JUNE 10, 2024

Town of Arlington Conservation Commission  
c/o Mr. David Morgan, Environmental Planner + Conservation Agent  
Robbins Memorial Town Hall  
730 Massachusetts Avenue  
Arlington, Massachusetts 02476

**RE: Stormwater Management, Soil Test Pits, and Groundwater Monitoring Summary  
Thorndike Place Residential Development**

# StormTrap Infiltration

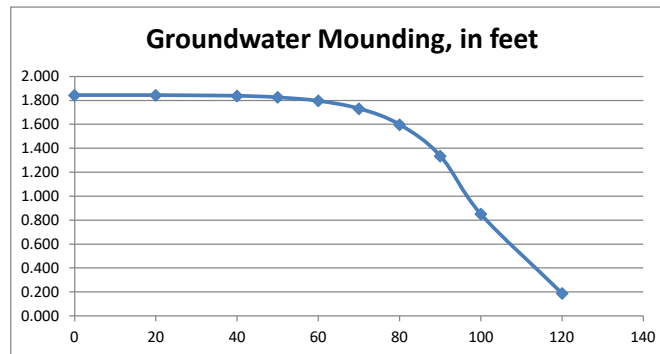
3. Review and, if necessary, resubmission of groundwater mounding analysis of the Stormtrap ST1 infiltration feature to demonstrate compliance. Provide a defensible basis for the selected horizontal

hydraulic conductivity and duration of infiltration period. Verify adequate separation if provided between the senior living complex and the mounded groundwater table.

*Based on discussions with the Commission, BSC has revised our groundwater mounding analysis and, it is our understanding, that this will be one of the items under additional peer review upon selection of a peer review consultant. A more detailed discussion of the revised groundwater mounding analysis is provided in the following sections.*

Utilizing the variable documented above and the dimensions of the infiltration systems, the maximum groundwater mounding beneath the infiltration systems are calculated to be 1.845-feet and 0.199-feet for the large and small systems, respectively. Both of these values are less than the provided separation to ESHGW, which is at least 2-feet in all systems. As such, the mounding analysis complies with the requirements of the DEP's Massachusetts Stormwater Handbook as groundwater mounds will not impact the systems' ability to infiltrate the required recharge volume nor will it break out above the land or water surface of a wetland. Please see the attached Hantush Method calculation sheet for details.
